Monthly Specification Update

Intel® Server Board S5520UR

Intel Order Number E69054-001

June 2013

Figure 1. Removing the Heatsink

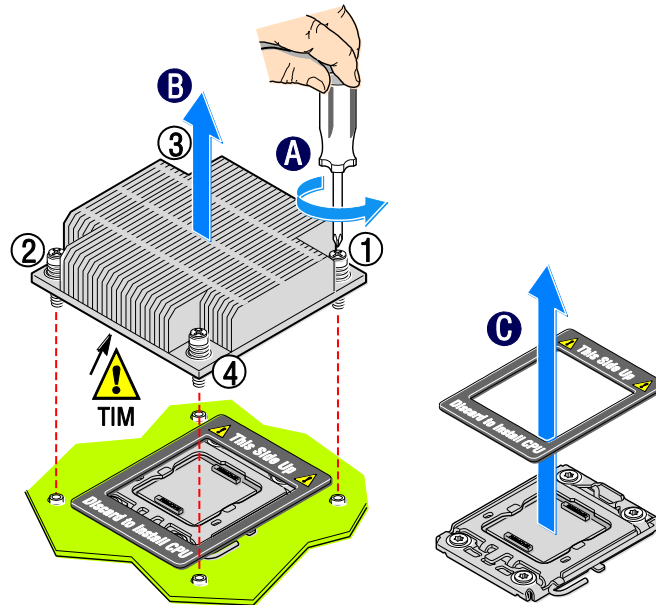
1. Proper Heatsink Installation and Removal Instructions are missing from Service Guide

1. Loosen the four captive screws on the heatsink corners in a diagonal manner according to the numbers shown in figure 1 as follows:
 - Starting with the screw at location 1, loosen it by giving it **two rotations** in the anticlockwise direction and stop. (**IMPORTANT:** Do not fully loosen.)
 - Proceed to the screw at location 2 and loosen it by giving it two rotations and stop.
 - Loosen screws at locations 3 and 4 by giving each screw two rotations and then stop.
 - Repeat steps 1a through 1c by giving each screw two rotations each time until all screws are loosened.
2. Do one of the following:
 - If removing the heatsink for the first time, do the following:
 - i. Lift the heatsink from the board.
 - ii. Remove and discard the spacer (see letter “C” in figure 1).

Figure 2: Installing the Heatsink

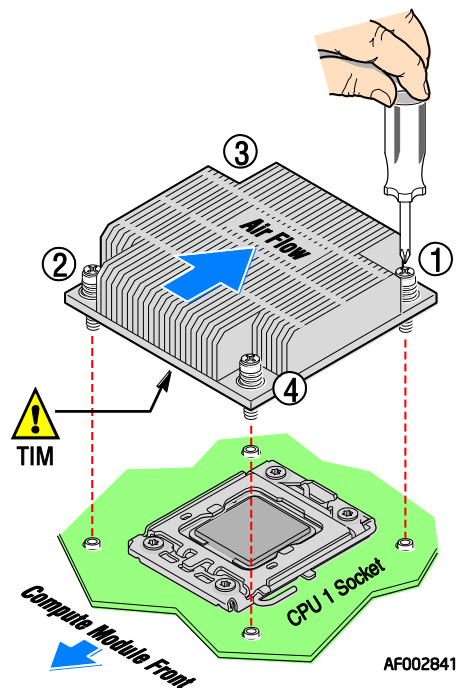
2. Orient the heatsink over the processor as shown in Figure 2. The heatsink fins must be positioned as shown to provide correct airflow through the system.

3. Set the heatsink over the processor, lining up the four captive screws with the four posts surrounding the processor.
4. Loosely screw in the captive screws on the heatsink corners in a diagonal manner according to the numbers shown in Figure 2 as follows:

- b. Proceed to the screw at location 2 and engage the screw threads by giving it two rotations and stop.
 - c. Engage screws at locations 3 and 4 by giving each screw two rotations and then stop.

- d. Repeat steps 4a through 4c by giving each screw two rotations each time until all screws are lightly tightened upto a maximum of 8 inch-lbs torque.
